UNITED STATES PATENT AND TRADEMARK OFFICE

10/581,513

Office Action Summary	Application No. 10/581,513	Applicant(s) KAY ET AL.	
	Examiner Phillip Gray	Art Unit 3767

DETAILED ACTION

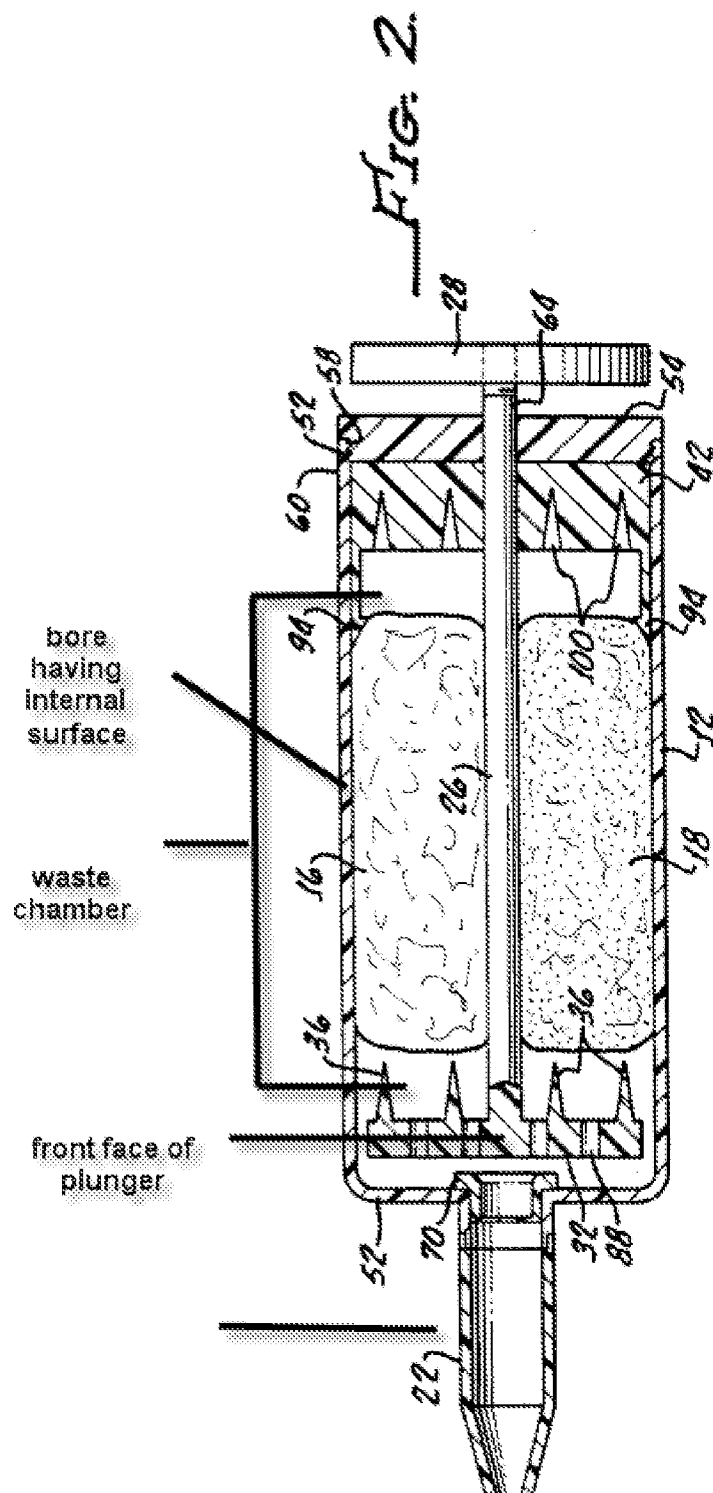
and end face opposite of the front face side surface, with a waste chamber (interior space which components 16 and 18 are contained in), a syringe barrel (12) with a nozzle (22) and bore (internal cavity and internal surface of 12), a seal formation (42) for sealing between the front face of plunger and said inner surface of the bore. See figure 2 and figure 4 marked up below.

Concerning claim 1 and seal formation.

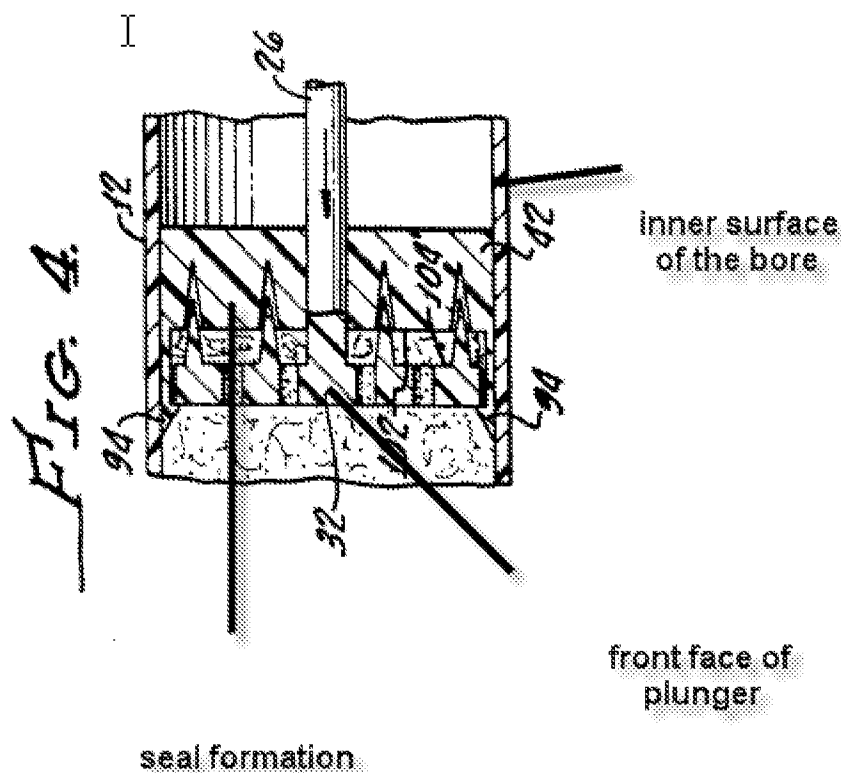
It is examiner's position that the seal formation (42) is provided "at" the end face of plunger 32, as shown in figures 4 and 6, since it is "near the area occupied by" and "near the position of" the end face; further it is towards the direction and location of the end face.

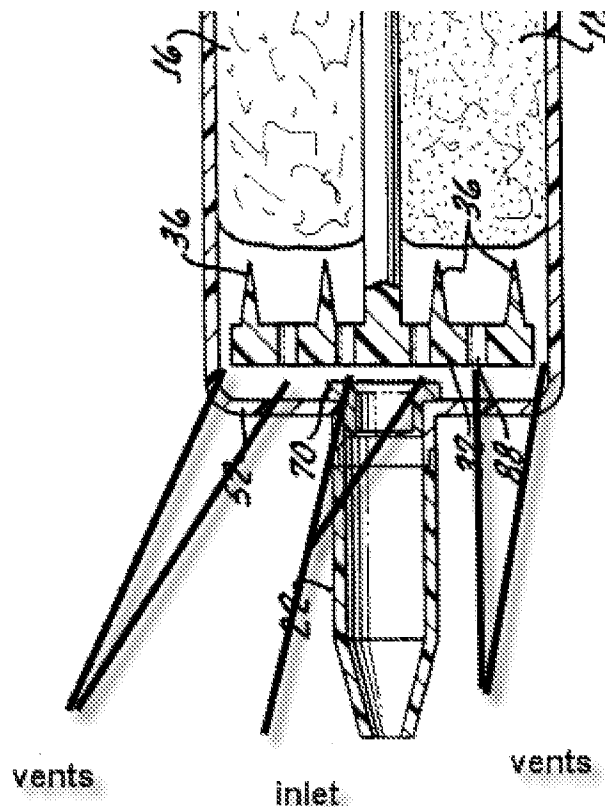
12). Concerning claim 6 it is examiners position that element 42 is a flexible wall within the device but substantially inextensible (incapable of being extended or stretched), Element 32 is of a finite size and does not expand or stretch. Concerning claim 7 note inlets (inner most 88). Concerning claim 8 see marked up lower part of figure 2 below.
